Design Standards Update

Design Update Training

Florida Department of
TRANSPORTATION

ROADWAY DESIGN BULLETIN 14-13

Index 501 – Geosynthetic Reinforced Soils

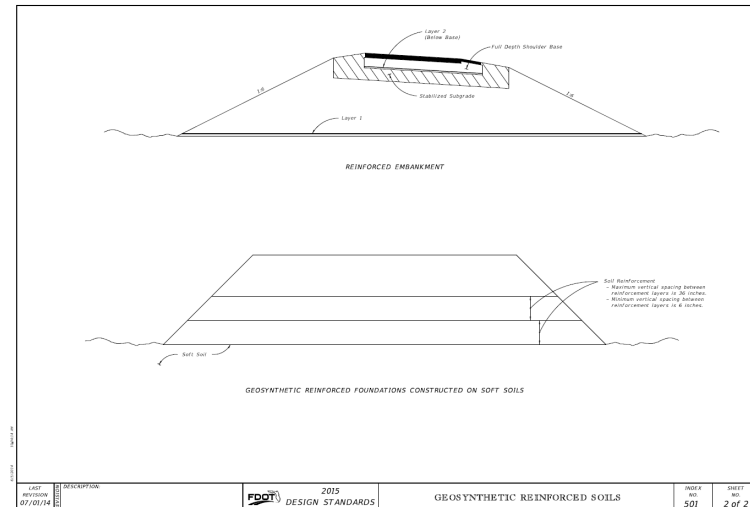
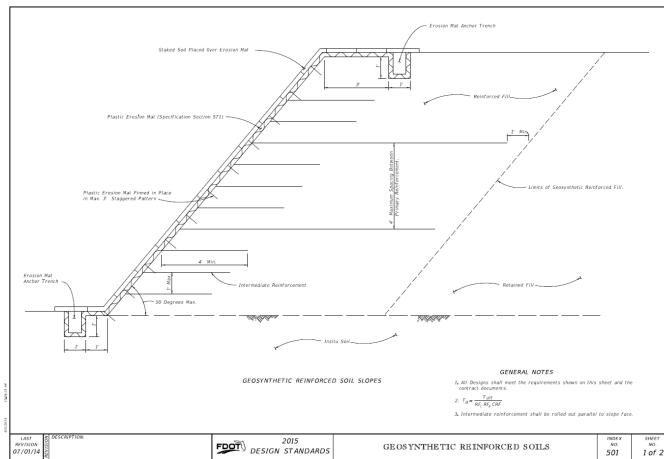
- ◆ All Geosynthetic Products have been moved from the Standard Index to the Approved Products List (Sheets 3 -11 have been removed).

ASYMMETRICAL W-THRIE BEAM TRANSITION PANEL
RWT02 (AASHTO-AGC-ARTBA Report) 10 Gauge

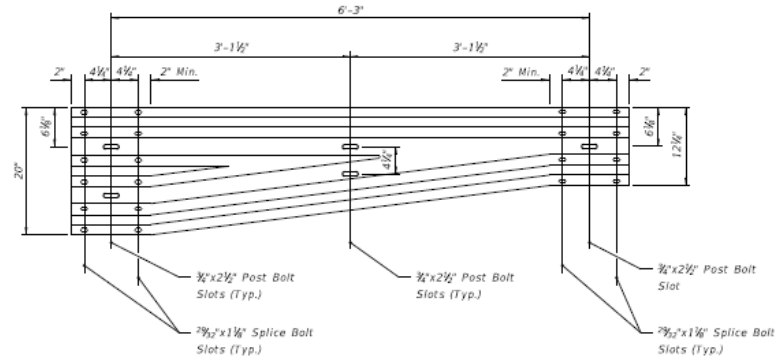
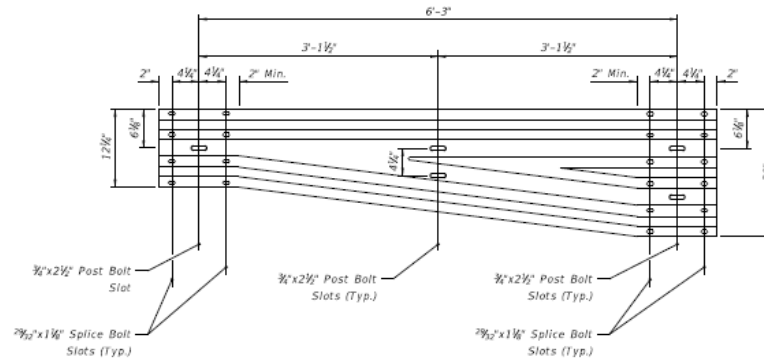
- ◆ Summary of major changes with RDB 14-05:
 - ✓ Mounting height for new installations increased from 1'-9" to 2'-1"
 - ✓ Asymmetrical W-beam to Thrie-beam transition section

12'-6" W-BEAM PANEL

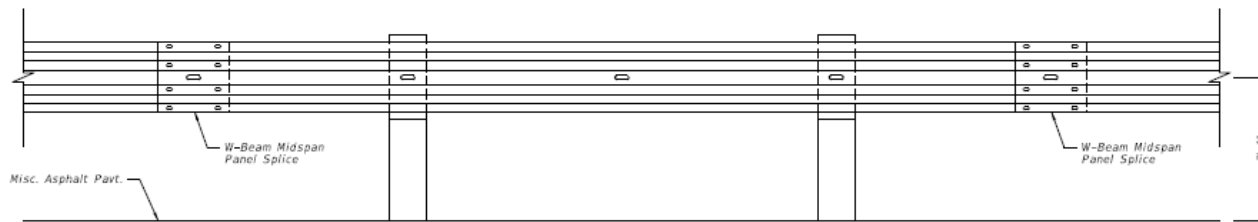
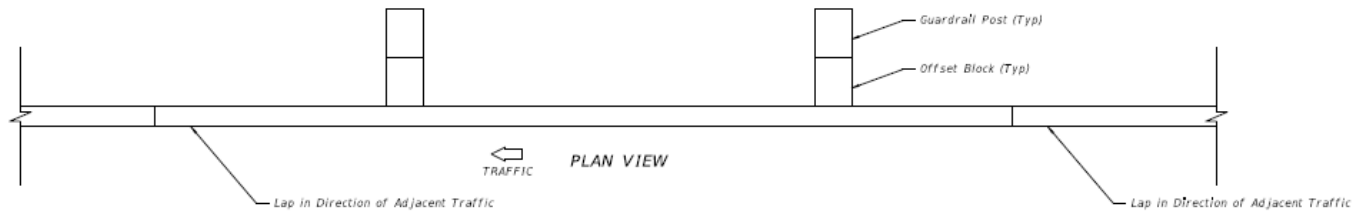
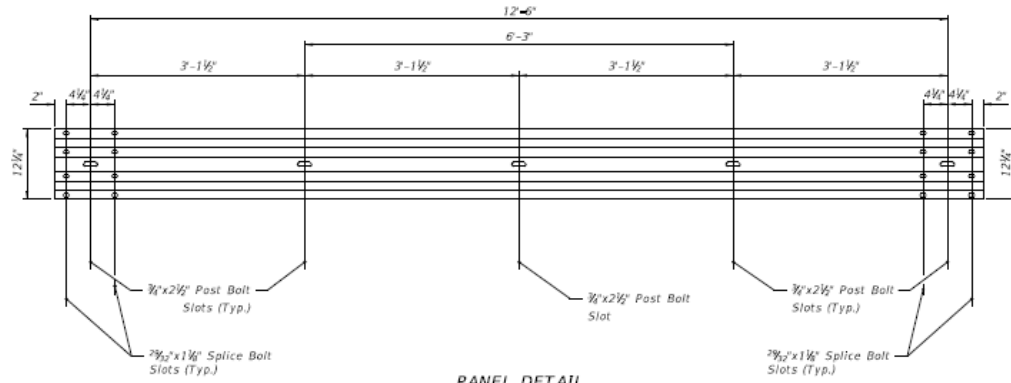
- ◆ Summary of major changes with RDB 14-05:
 - ✓ Mounting height for new installations increased from 1'-9" to 2'-1"
 - ✓ Asymmetrical W-beam to Thrie-beam transition section
 - ✓ W-beam panel joints shifted from the posts to the center of the span between posts
 - ✓ Standard W-beam panel revised to accommodate all post orientations and spacing in 3'- 1 ½" increments

5-SPACE 15'-7 1/2" W-BEAM GUARDRAIL PANEL

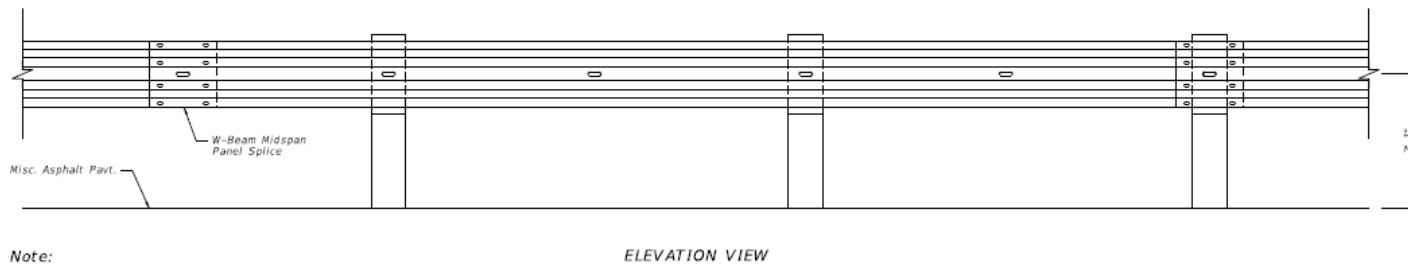
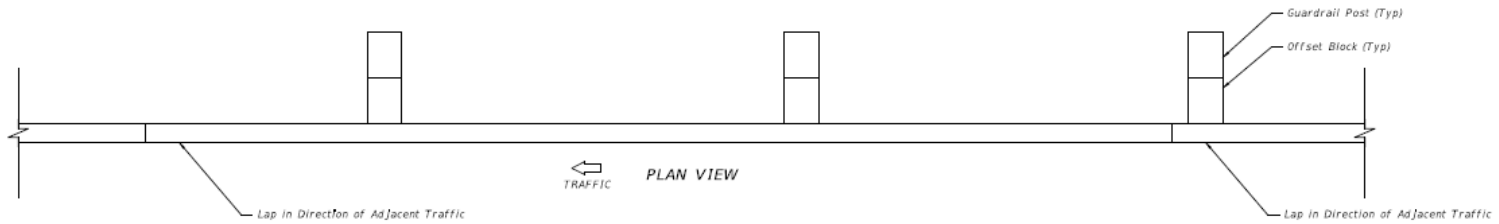
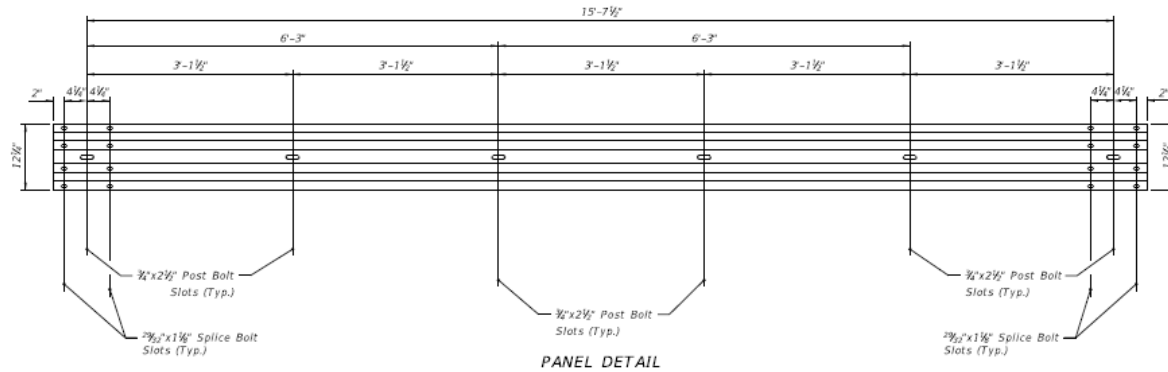
- ◆ Summary of major changes with RDB 14-05:
 - ✓ Mounting height for new installations increased from 1'-9" to 2'-1"
 - ✓ Asymmetrical W-beam to Thrie-beam transition section
 - ✓ W-Beam panel joints shifted from the posts to the center of the span between posts
 - ✓ Standard W-Beam panel revised to accommodate all post orientations and spacing in 3'- 1 ½" increments
 - ✓ Added special 15'-7 ½" W-beam panel to allow splice location shift from post to midspan

1. The 5-Space 15'-7 1/2" W-beam Guardrail Panel shall be used at the downstream end of an End Anchor System that does not offset the W-beam Panel Splice to Midspan.

5-SPACE 15'-7 1/2" W-BEAM GUARDRAIL PANEL WITH BEAM ANCHOR PLATE ATTACHMENT

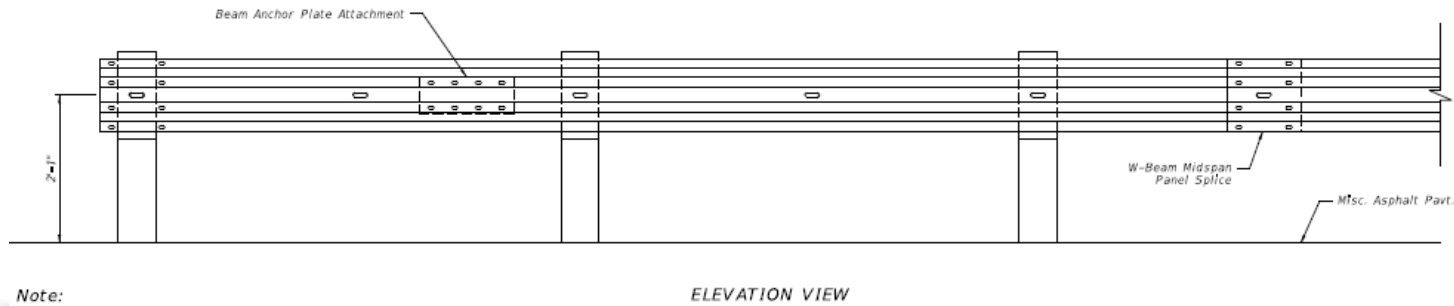
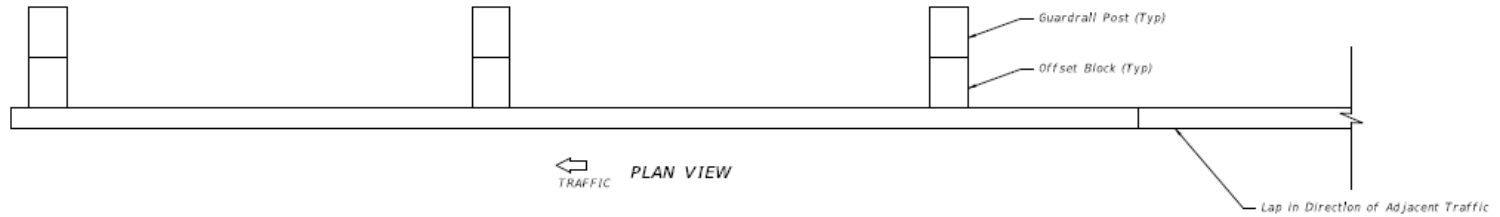
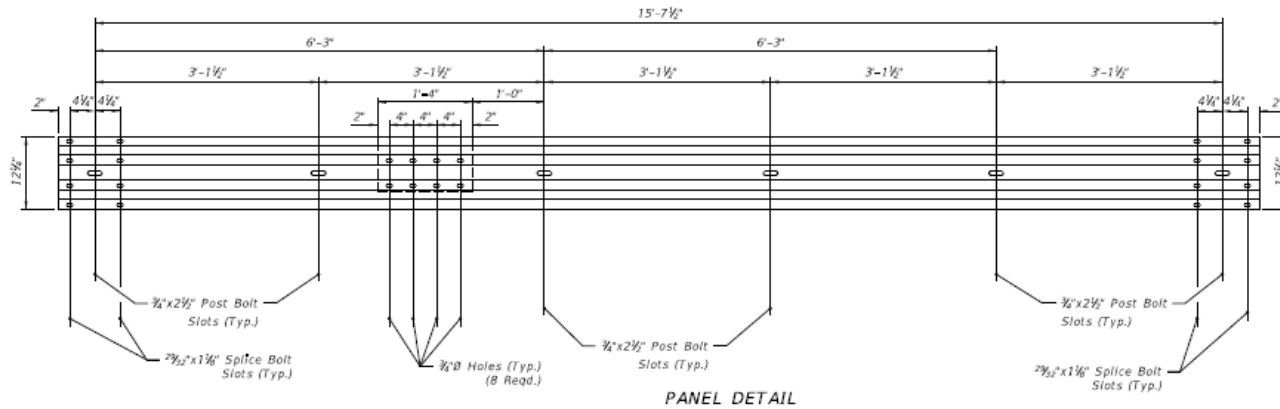
- ◆ Summary of major changes with RDB 14-05:
 - ✓ Mounting height for new installations increased from 1'-9" to 2'-1"
 - ✓ Asymmetrical W-beam to Thrie-beam transition section
 - ✓ W-Beam panel joints shifted from the posts to the center of the span between posts
 - ✓ Standard W-Beam panel revised to accommodate all post orientations and spacing in 3'- 1 ½" increments
 - ✓ Added special 15'-7 ½" W-beam panel to allow splice location shift from post to midspan
 - ✓ Added detail for 15'-7 ½" W-beam End Anchorage Panel with Anchor Plate Attachment for End Anchorage Assemblies

- The 5-Space 15'-7 1/2" W-beam Guardrail Panel with Beam Anchor Plate Attachment shall be used to Anchor the Type II or Type CRT End Anchorage Assemblies.

SECTION VIEW

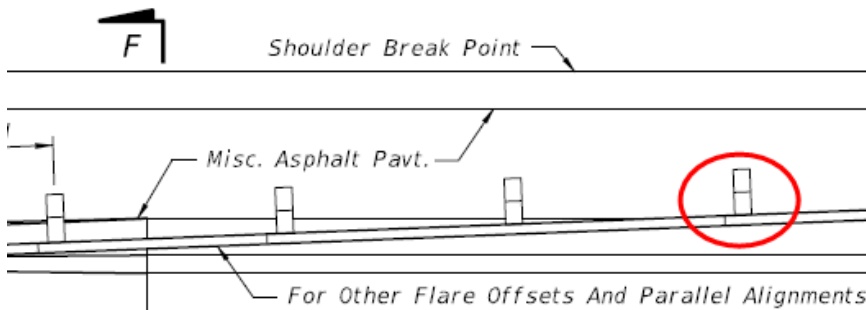
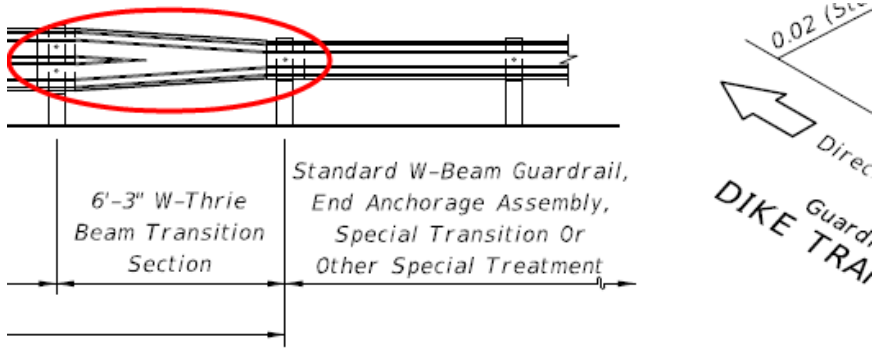
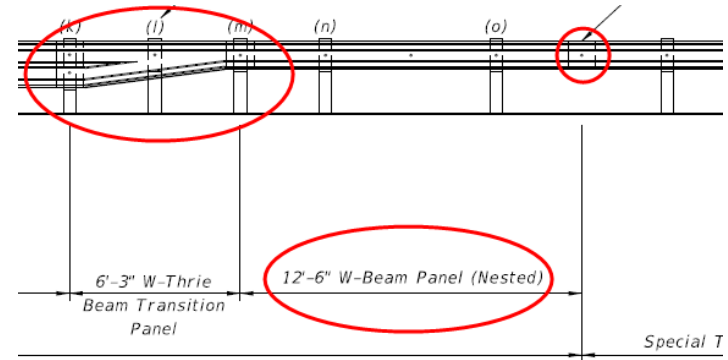
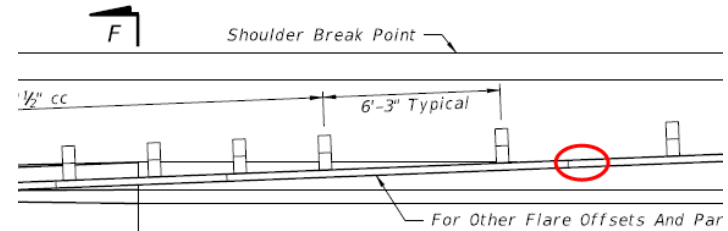
- ◆ Summary of major changes with RDB 14-05 (cont.):
 - ✓ Approach transition details (Detail J) modified
 - Length increased from 43'-9" to 56'-3"
 - Required to accommodate additional W-beam panel (nested)
 - Asymmetrical W-beam to Thrie-beam transition section

FLARED OPTION
PLAN VIEW

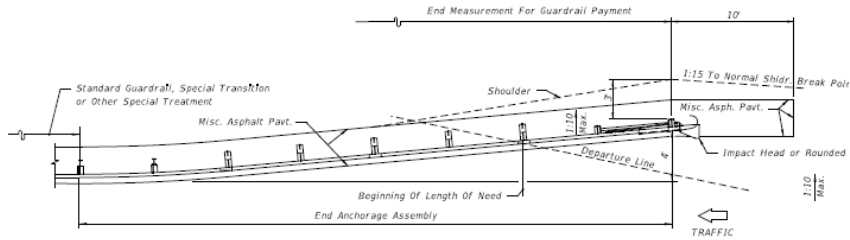
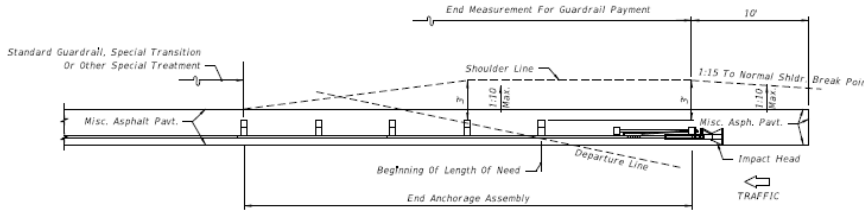
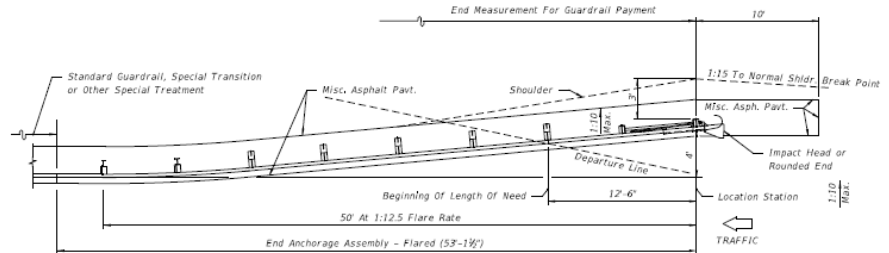
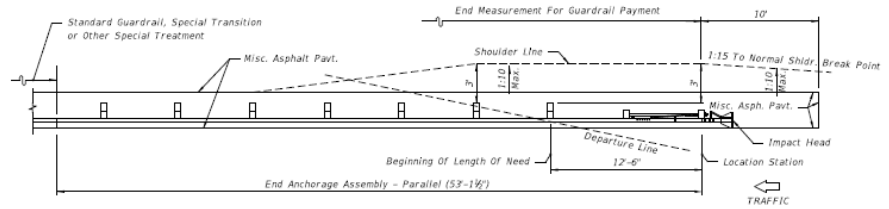
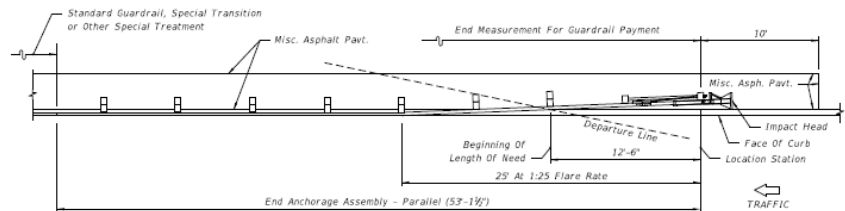
- ◆ Summary of major changes with RDB 14-05 (cont.):
 - ✓ Approach End Anchorage Assembly lengths increased
 - Requires a 15'-7 ½" W-beam panel to shift the splice location
 - APL drawings will show each system within the:
 - 53'-1 ½" for TL-3 systems
 - 40'-7 ½" for TL-2 systems

ELEVATION VIEW

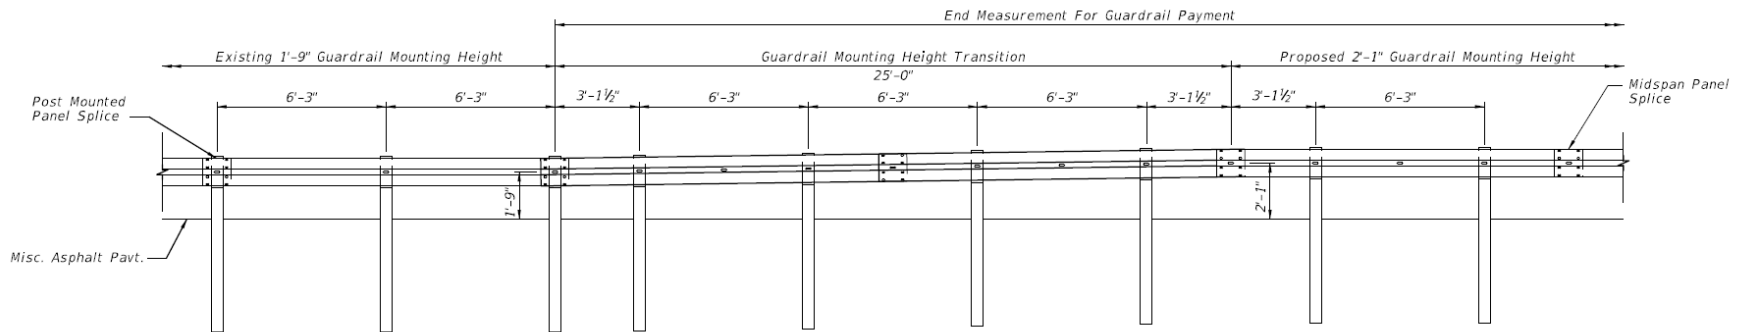
- ◆ Summary of major changes with RDB 14-05 (cont.):
 - ✓ Added detail for height transition from 1'-9" mounting height to 2'-1" mounting height
 - To be used in special cases as determined by the District where connecting long runs of new guardrail to long runs of existing guardrail
 - Ensure opposite end of new guardrail run is not bound by fixed barrier. Must use whole panel lengths.

RUB RAIL TERMINATION

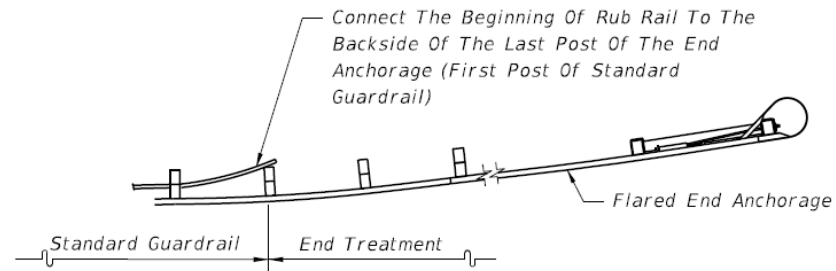
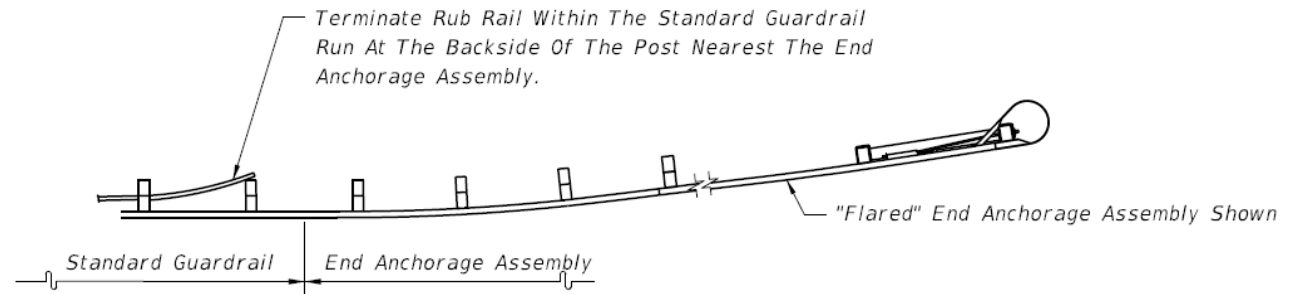
- ◆ Summary of major changes with RDB 14-05 (cont.):
 - ✓ Rub rail terminates at the first post in advance of the End Anchorage Assembly
